RE: Final Environmental Assessment (FEA) for the Maui Lu Redevelopment
Project Located at TMK 3-9-001: 083, 086 & 120, Kihei, Island of Maui,
Hawaii (EA 2003/0008)

FINAL
HRS CHAPTER 343
ENVIRONMENTAL ASSESSMENT
**MAUI LU
REDEVELOPMENT**

*575 · South Kihei · Road
Kihei · Maui · Hawaii
TMK: (2) 3-9-001:083, 086, & 120*

SEPTEMBER 2004

FIGURE 5.1

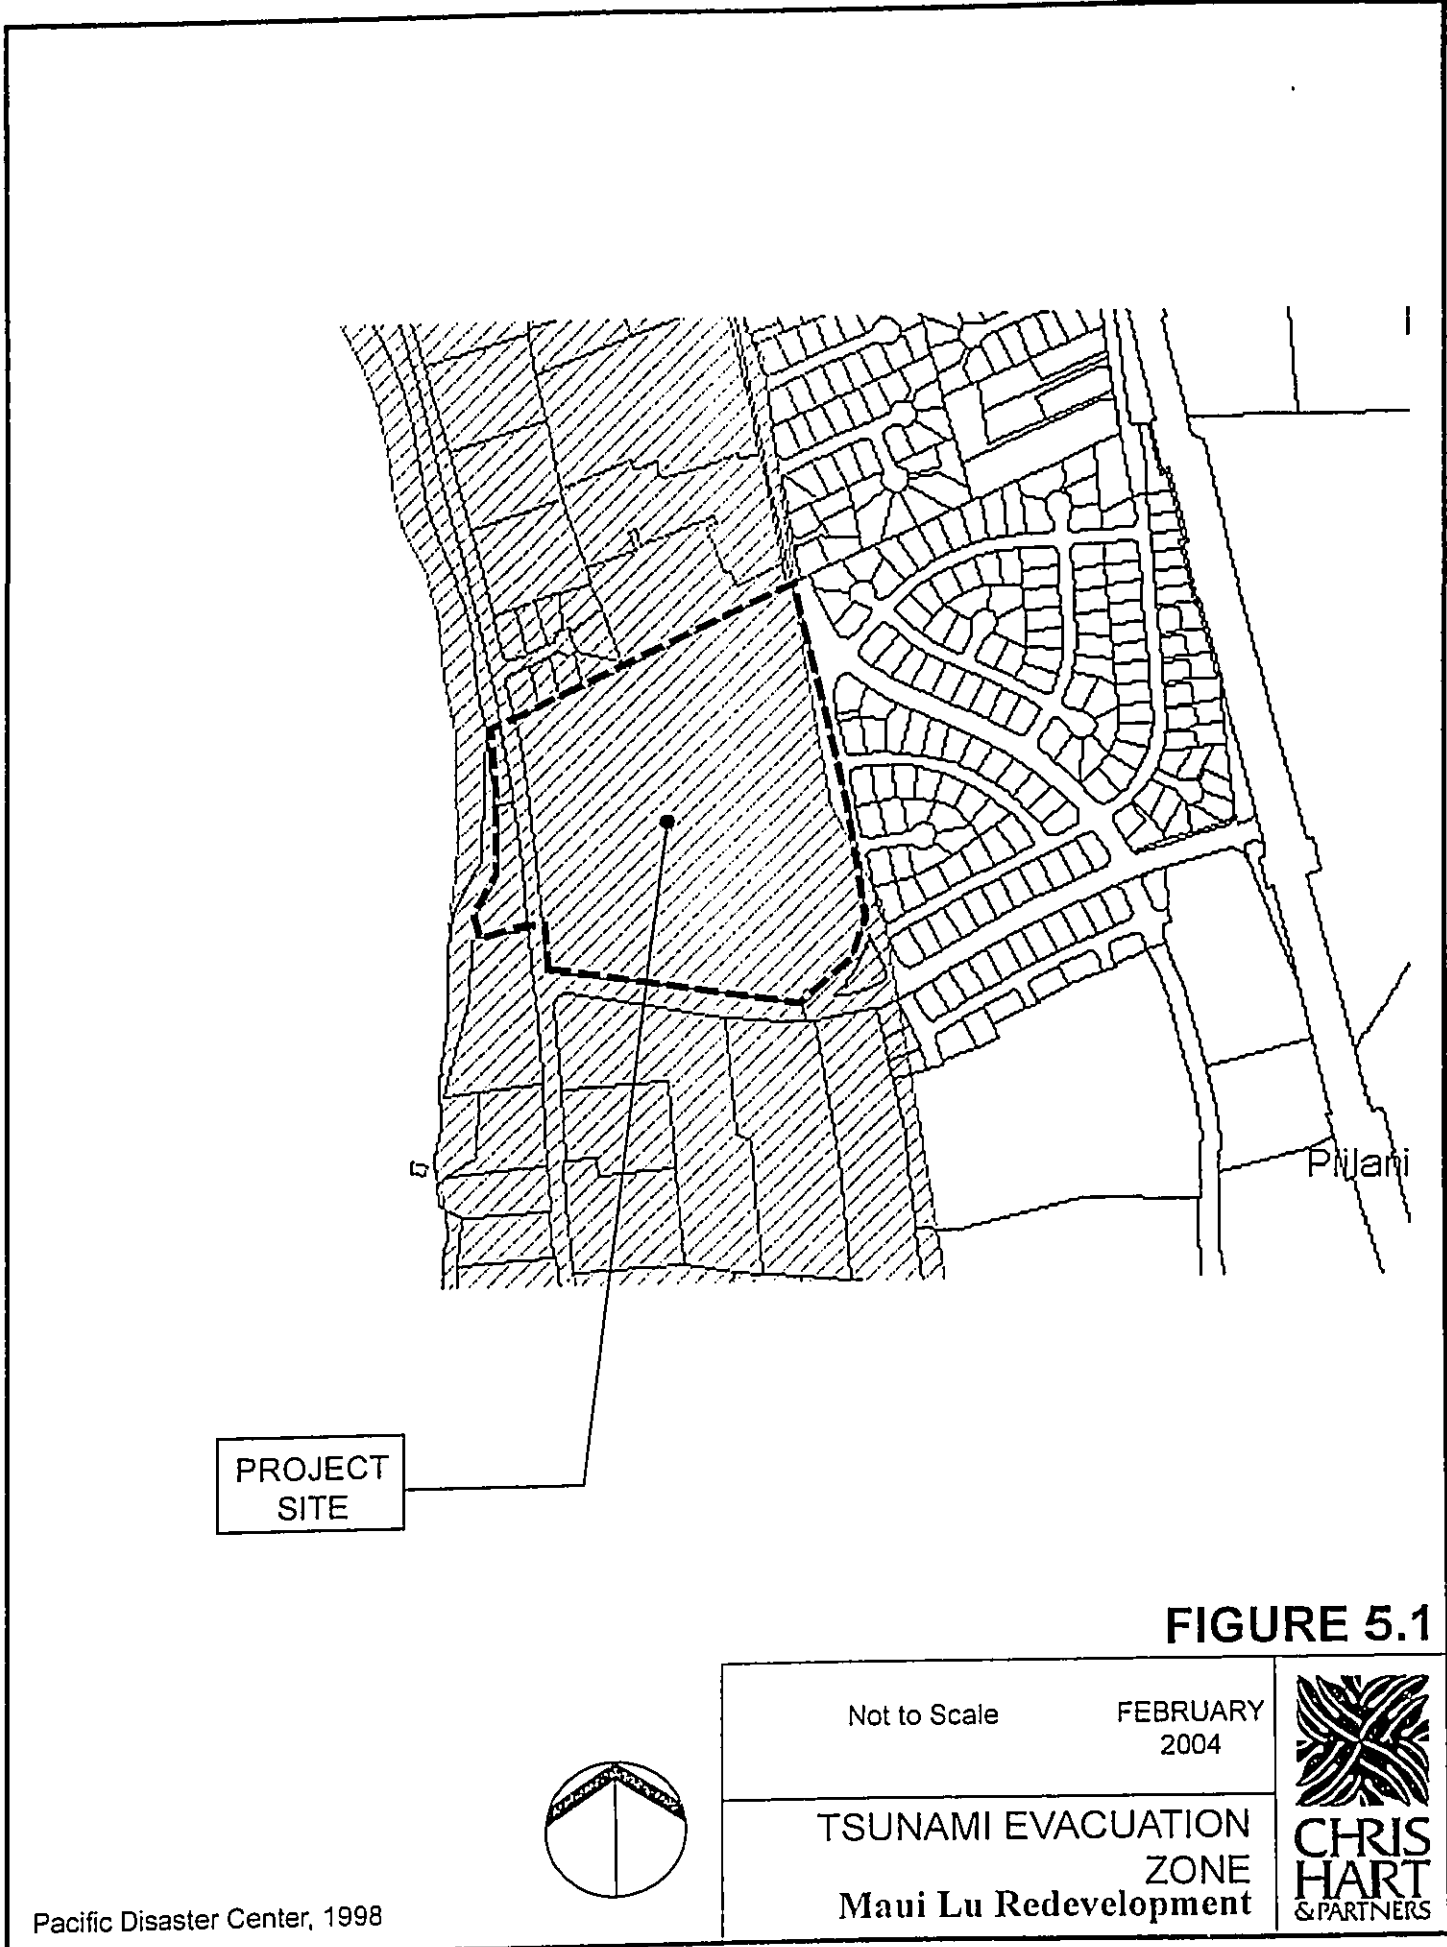
8. Delineate the tsunami inundation line on Figure 5 of the DEA.
9. Drainage Analysis
 - a. Provide a drainage analysis using the 100-year storm calculations.

8. Tsunami Inundation. Figure 5.1 (See: Attachment 4) will be added to delineate the tsunami inundation line which typically includes all parcels *mauka* to Alulike Street/Kenolio Road.
